**Draft decision**

**TransGrid transmission determination**

**2015–16 to 2017–18**

**Attachment 6: Capital expenditure**

**Figure A-1: TransGrid's augex—historic and proposed for 2014-18 period (million \$2013/14)**

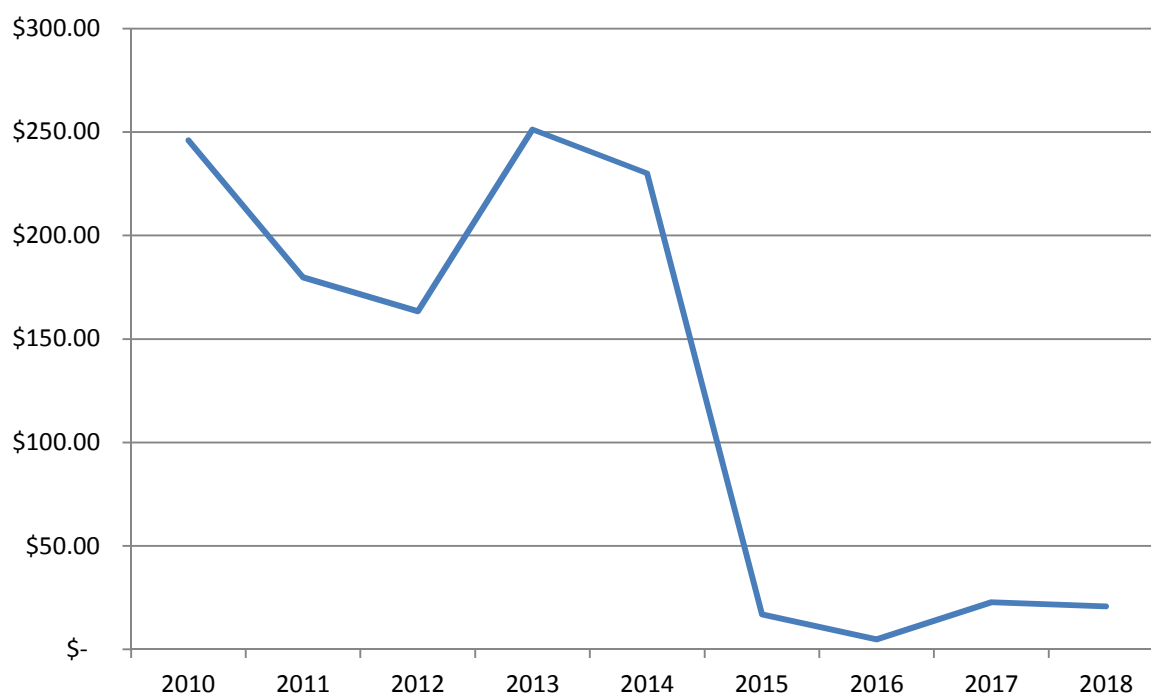
Figure A-1 shows that this is a significant reduction from the amount of augex TransGrid spent during the 2009–2014 period. The average annual augex for the 2014–2018 period is \$197.7 million (\$2013–14) lower than for the 2009–2014 regulatory control period. This is a 92 per cent reduction.

**Figure A-2: Repex actual and forecast trend from 2004-05, (inflation adjusted)**

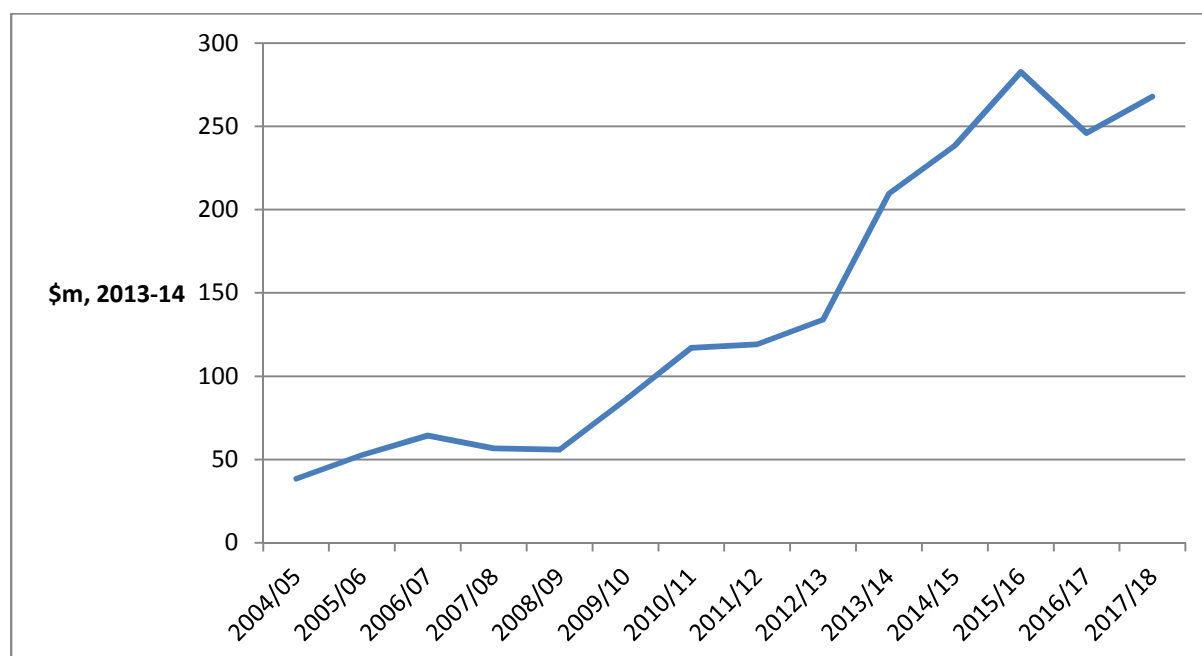
TransGrid's proposed average annual repex over the 2014–2018 period is \$231.3 million (\$2013–14) per year. This compares to average annual repex of \$155.8 million (\$2013–14) over the 2009–2014 regulatory control period, an increase of 48 per cent.<sup>36</sup> This substantial increase is shown in Figure A-2. The actual repex that TransGrid spent during the 2009–2014 regulatory control period is also a significant overspend in comparison to the forecast. Several submissions expressed concern at the increase in TransGrid's proposed repex.<sup>37</sup>

**Figure A-5 Trend in TransGrid's security/compliance expenditure**

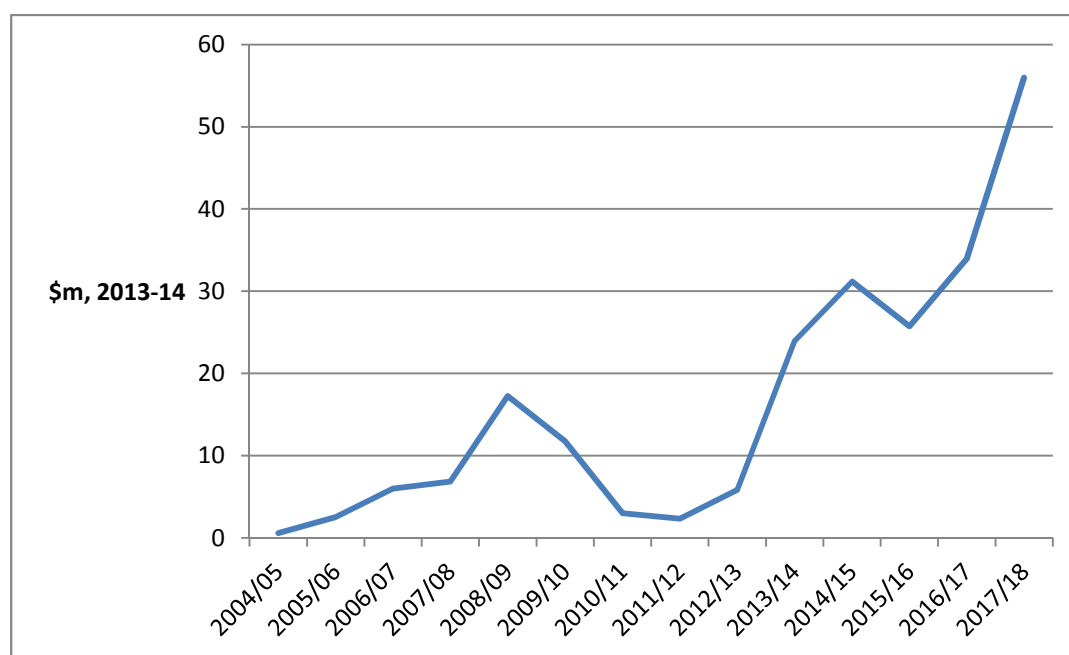
TransGrid's proposed security and compliance capex of \$129.6 million for the 2014–2018 period represents an average annual increase of 80 per cent when compared to expenditure in the 2009–2014 regulatory control period. The trend in TransGrid's security and compliance expenditure is shown in Figure A-5.

**Figure A-6 TransGrid's strategic property capex 2004-05 to 2017-18 (\$million, 2013-14)**

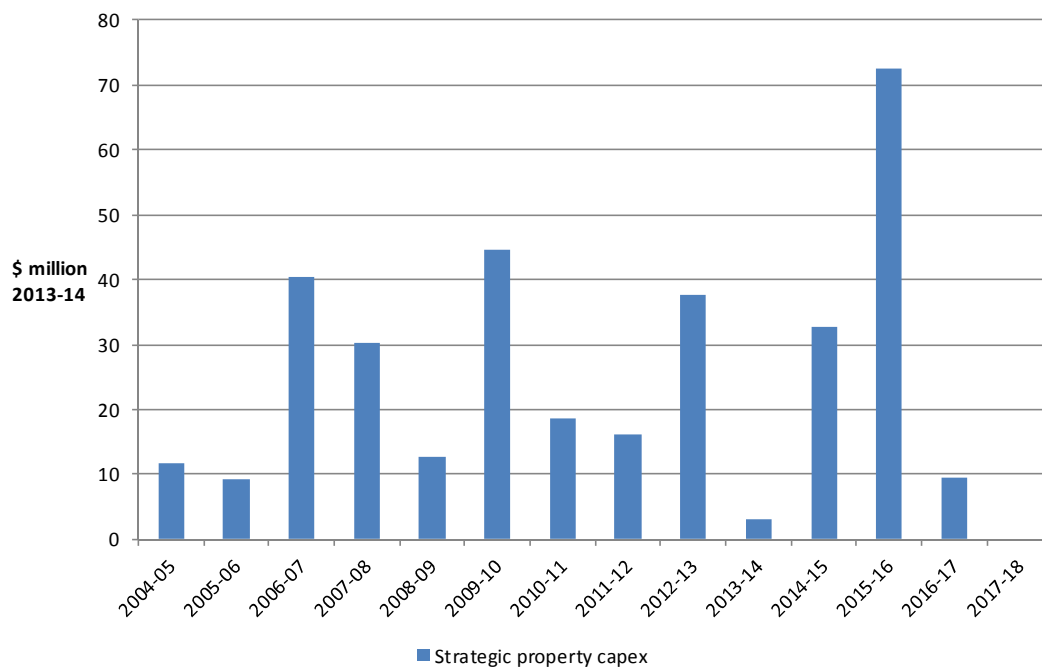
TransGrid's forecast strategic property capex for the 2014–18 period is four per cent lower than actual and expected capex in the 2009–14 regulatory control period, but 10 per cent higher than expenditure in the 2004–09 regulatory control period.<sup>119</sup> Forecast capex is concentrated in the first three years of the 2014–18 period, with a significant spike in expenditure in the 2015–16 year. As can be seen in Figure A-6 strategic property capex requirements are variable from year to year. Individual property acquisitions are driven by the future development needs of the network. However, in a period of low maximum demand growth and limited augmentation requirements, we consider that TransGrid's forecast strategic property capex program warrants further review at the project level to confirm the need and timing for the proposed expenditure.
